ADDENDUM NUMBER 02

PROJECT: **GTC – Greenville – Bldg. 103 Bookstore Expansion**
GMC PROJECT NO. AGRE200029
OSE PROJECT NO. H59-N046-PD

H7 ENLARGED PLAN - CHECKOUT
SCALE: 3/4"=1'-0"

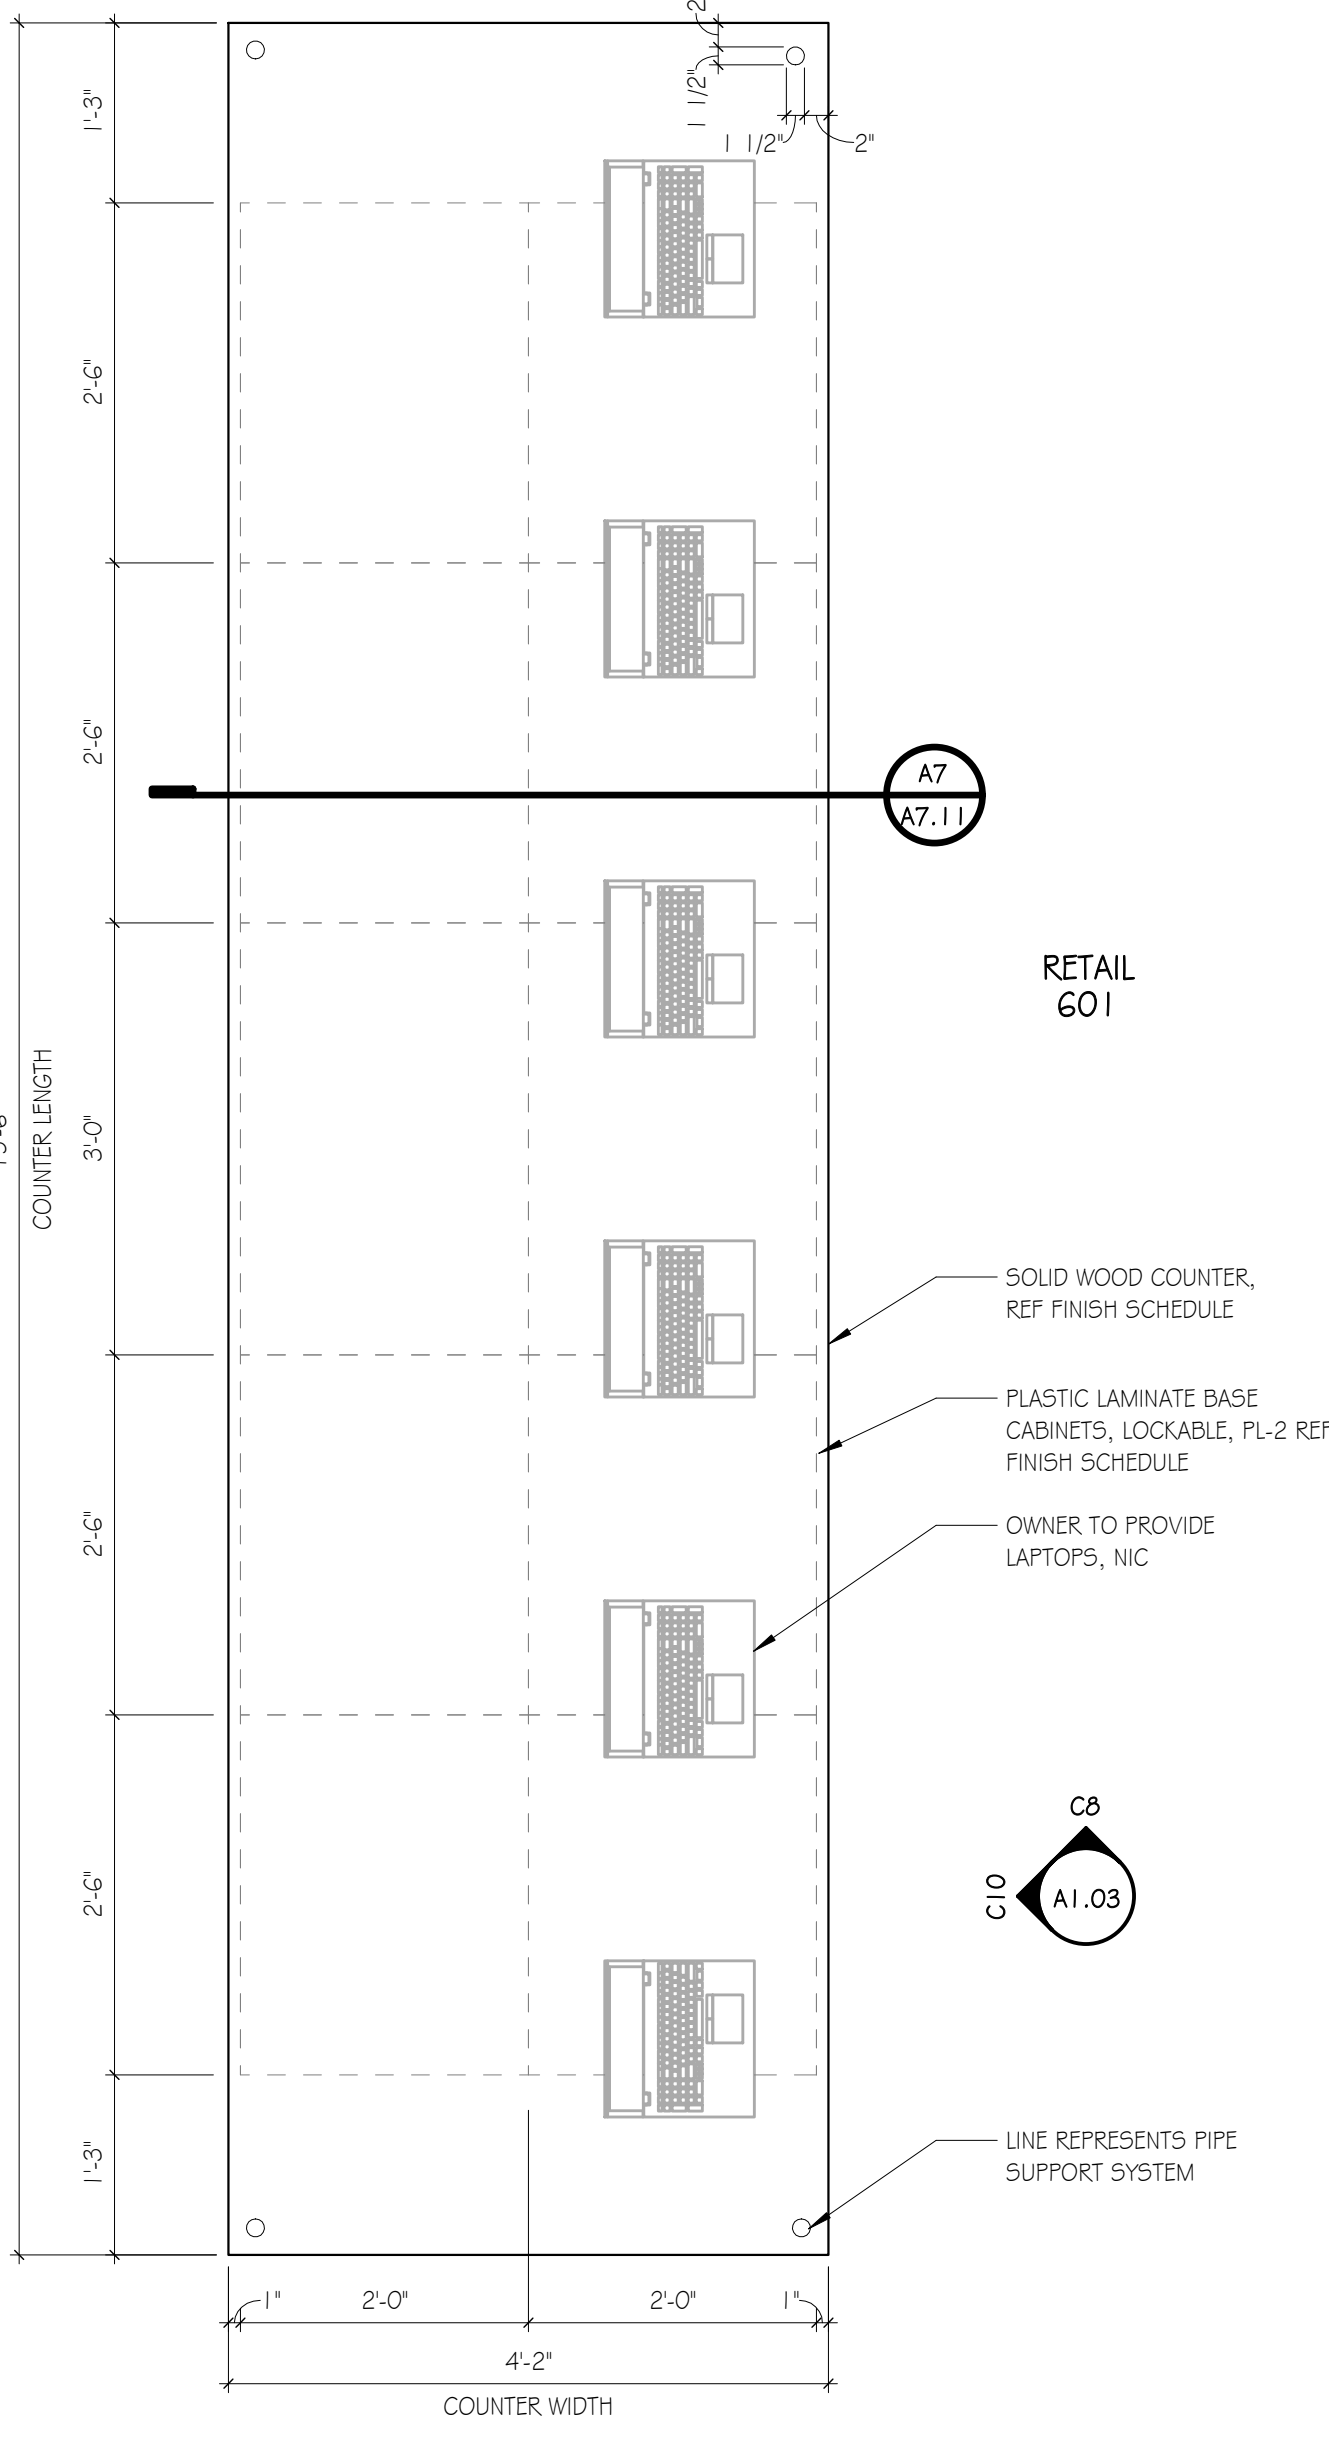
- A2Q19 There is a 12” metal letter sign called out on the reflected ceiling plan above the checkout counter. We cannot find an elevation showing what this sign should say. Please provide. – **The sign should read “C H E C K O U T”. Letters to be equally spaced on pipe to match similar signage.**

A4 INT. ELEV.
SCALE: 1/2"=1'-0"

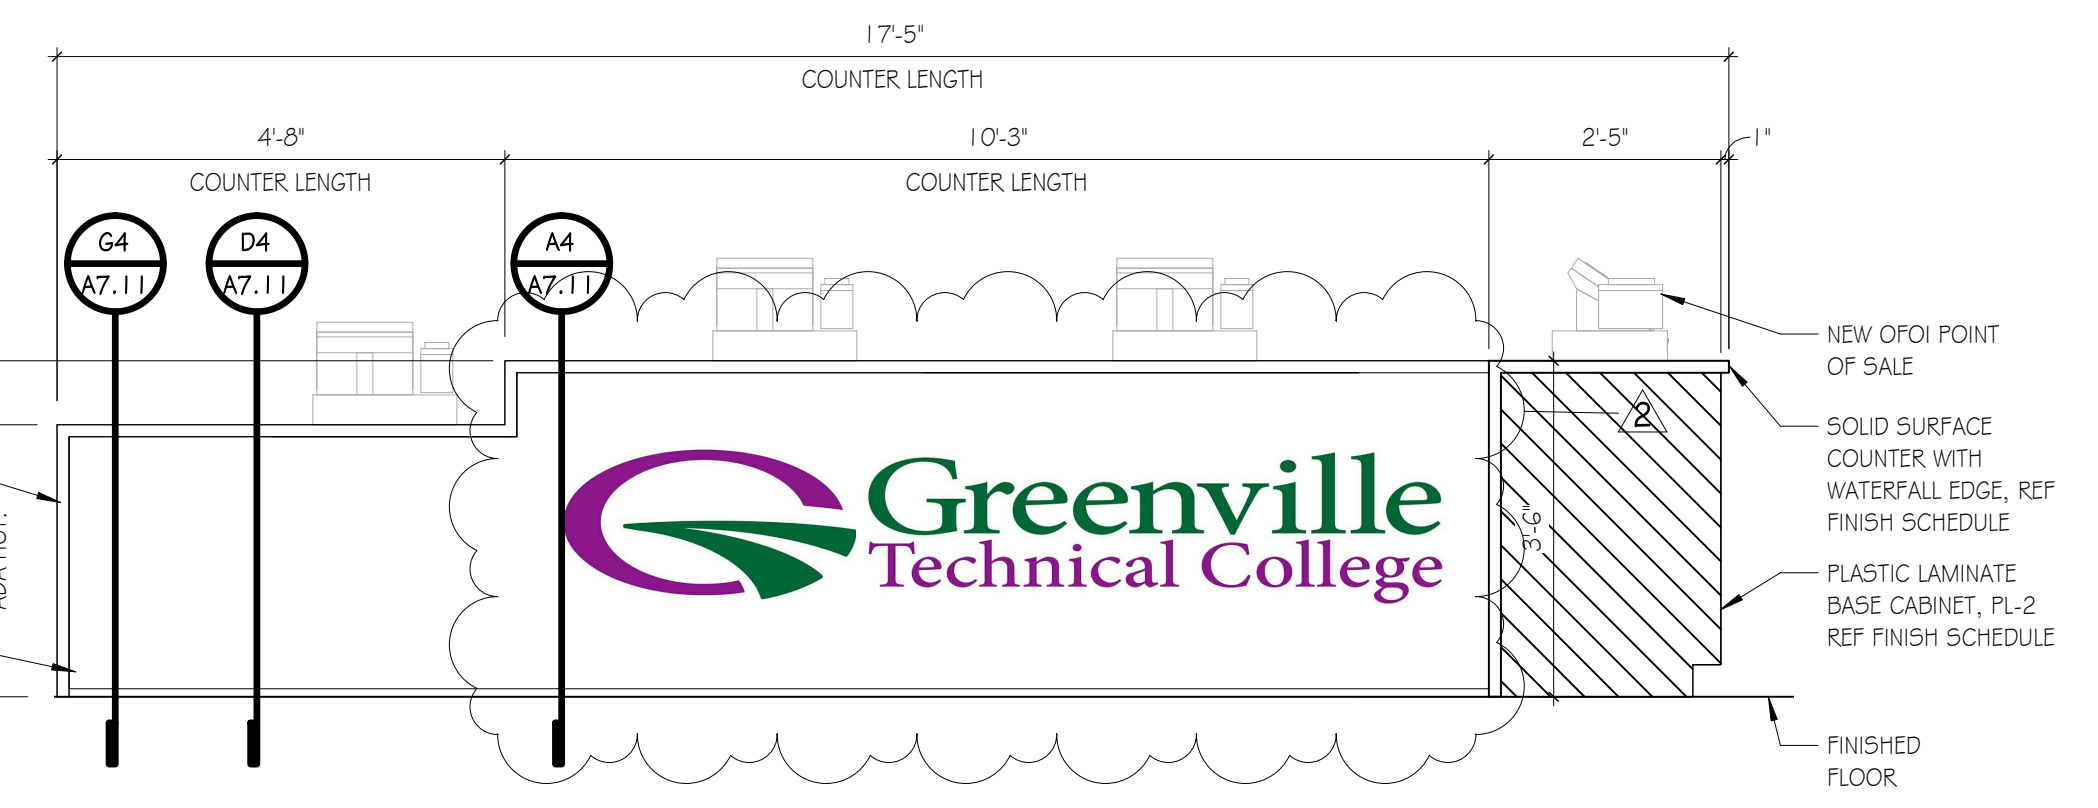
- A2Q21 Sign note #15 on page A1.02 – What is the actual size of that sign? What will it say? – **Reference D10 on A4.02**
- A2Q22 The sign shown on page A1.03 detail A8 – SI that the same sign as shown on drawing A8, detail H8 or are the two signs separate signs? – **They are the same, H8 on sheet A8.01 is an enlarged view of A4 on A1.03. Graphics and dimensions indicated on H8, A8.01 shall govern.**

E1 FINISH PLAN
SCALE: 1/8" = 1'-0"

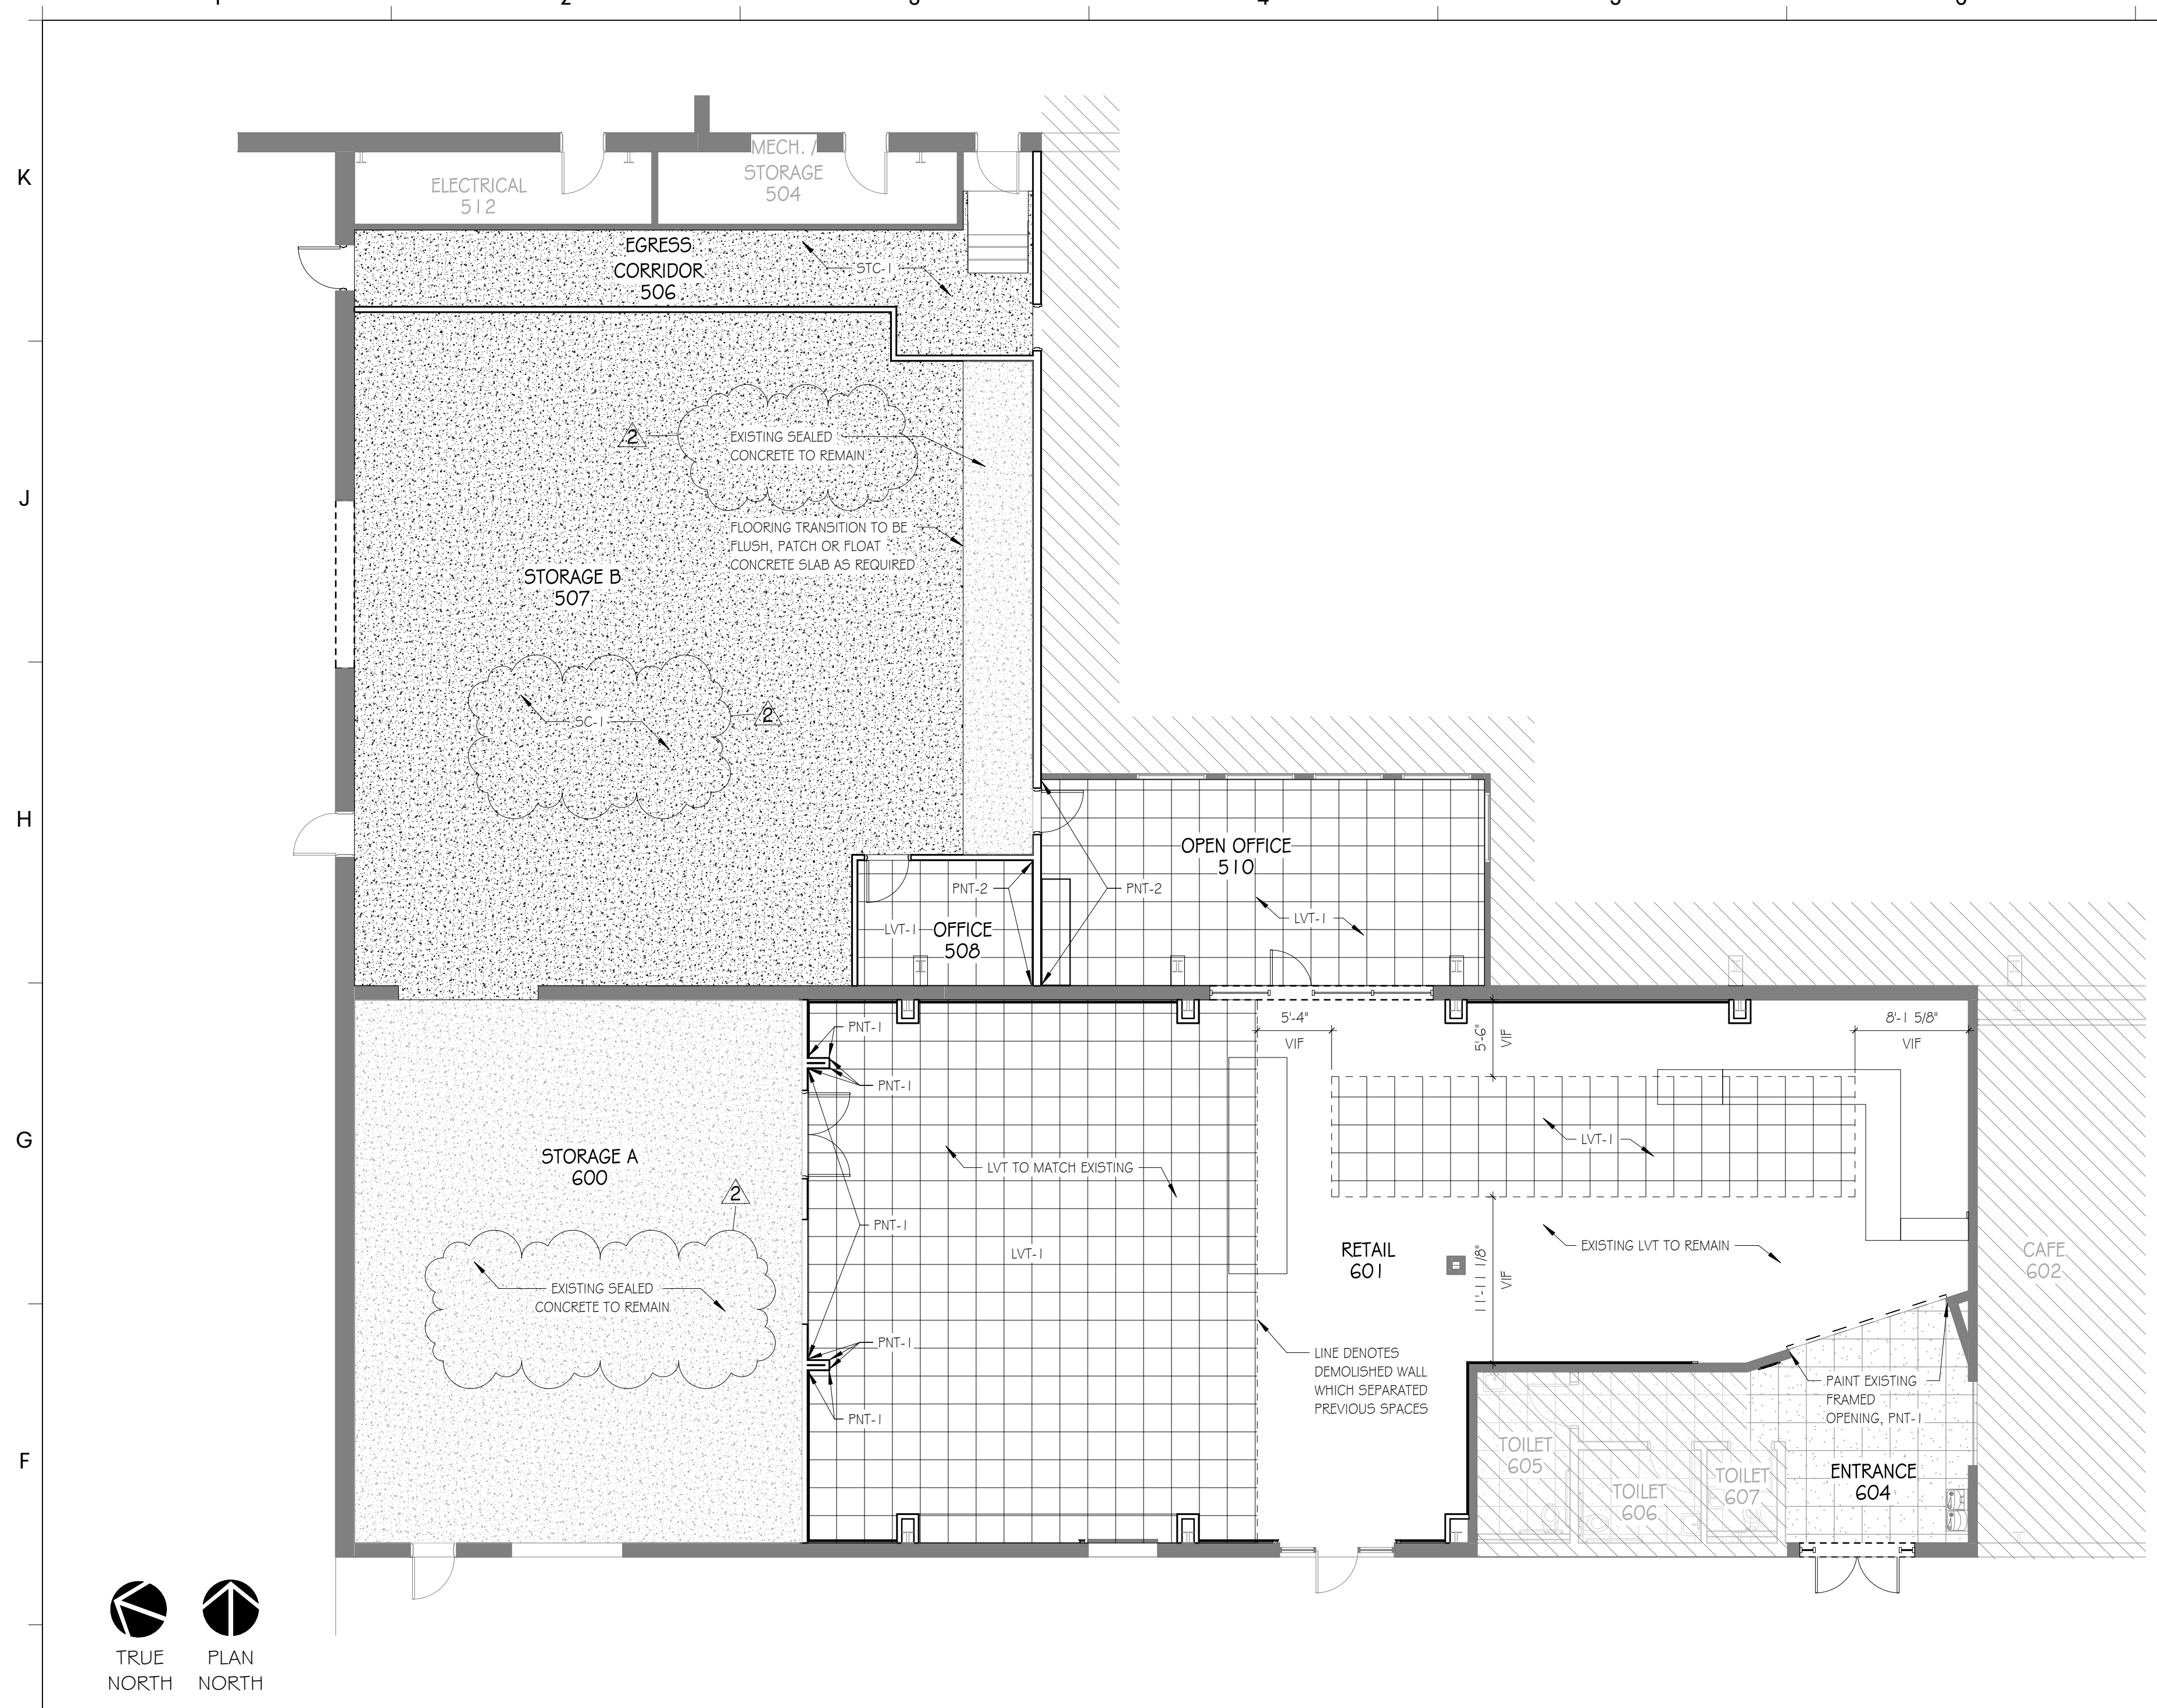
- A2Q6 A8.01 Finish Plan calls for STC-1 for the floors in rooms 506, 507, & 600. The finish legend and specs do not indicate what product this is. Please provide more info on this floor finish. – **Reference project manual section 071900 – Water Repellents**

- A2Q26 On drawing A8.01 the floor finishes call for SC-1 sealed concrete, but on the finish plan it is shown as STC-1. Can you please confirm that we are to seal the concrete, not stain the concrete? - **There is no stained concrete in project scope. Areas indicated as STC-1 shall be SC-1.**
